HISTORIC AND DESIGN REVIEW COMMISSION

HDRC CASE NO: 2020-117
ADDRESS: 230 ADAMS ST
LEGAL DESCRIPTION: NCB 943 BLK 1 LOT SW 100 FT OF 16
ZONING: RM-4 CD, H
CITY COUNCIL DIST.: 1
DISTRICT: King William Historic District
APPLICANT: David Robertson/Build Modern LLC
OWNER: Esteban Lopez
TYPE OF WORK: Window replacement
APPLICATION RECEIVED: March 02, 2020
60-DAY REVIEW: Not applicable due to City Council Emergency Orders
CASE MANAGER: Edward Hall

REQUEST:

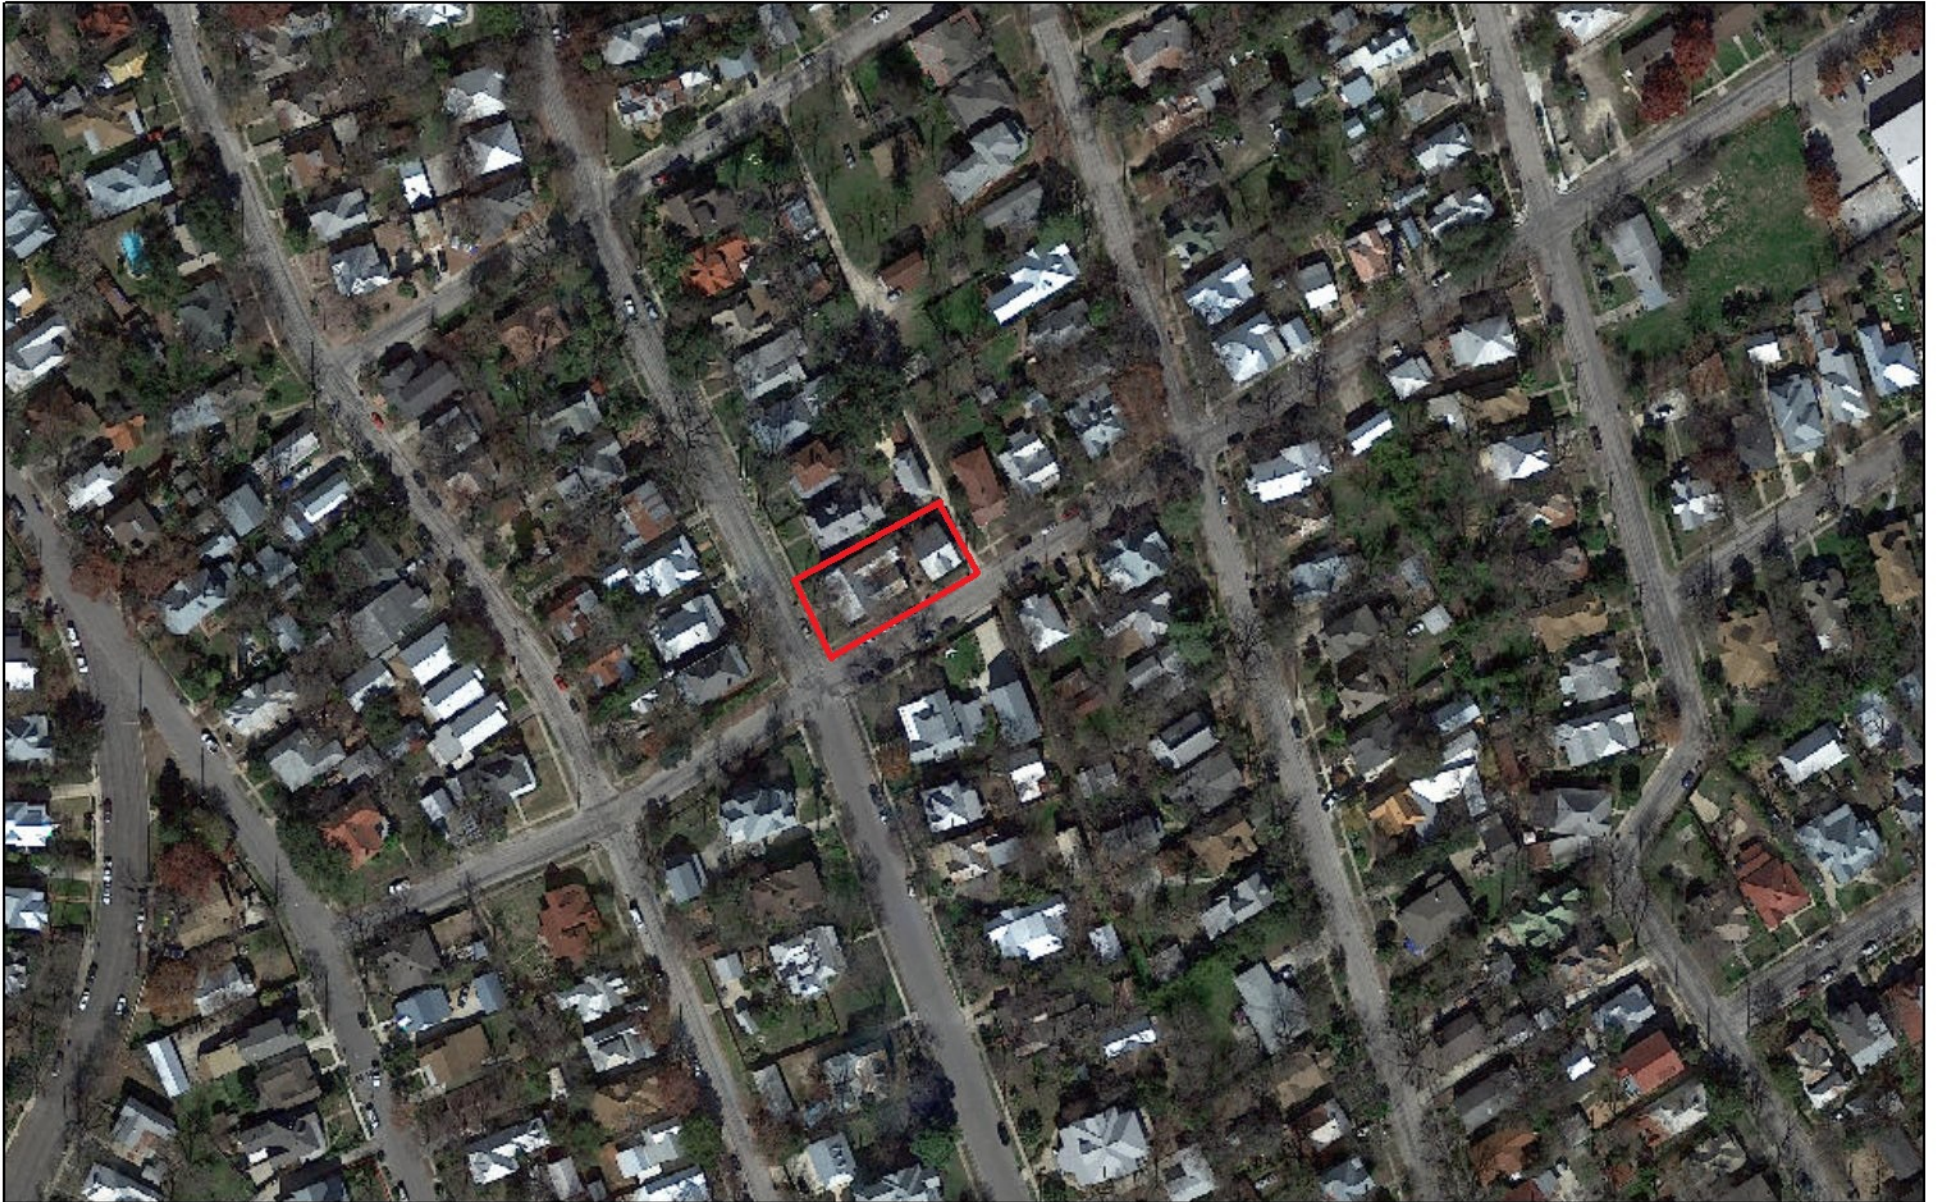
- c. **WINDOW RELOCATION** – The applicant has proposed to relocate salvageable wood windows from the north, east and south facades to the west (front) façade. Staff finds this request to be appropriate. Additionally, staff finds that

any windows that are in repairable conditions, or their elements are to be salvaged and installed in other window openings.

1. Staff recommends approval of item #1, the relocation of existing, salvageable wood windows from the north, east and south facades to the west façade as noted in finding c with the stipulation that any other windows, sashes, or their elements that are in a salvageable condition be repaired and installed on other facades.
2. Staff recommends approval of item #2, the installation of new wood windows provided that they are custom fabricated to match the existing in terms of size, type, configuration, material, form, appearance and detail, as noted in finding d.

JELD-WEN W-2500 Series Primed Wood Double Hung w/ natural interior and low e glass.

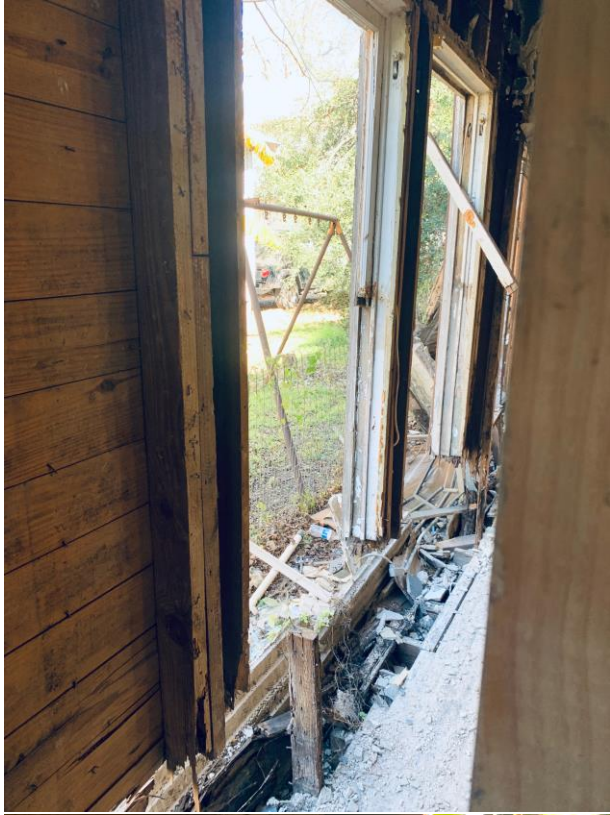
The windows selected:
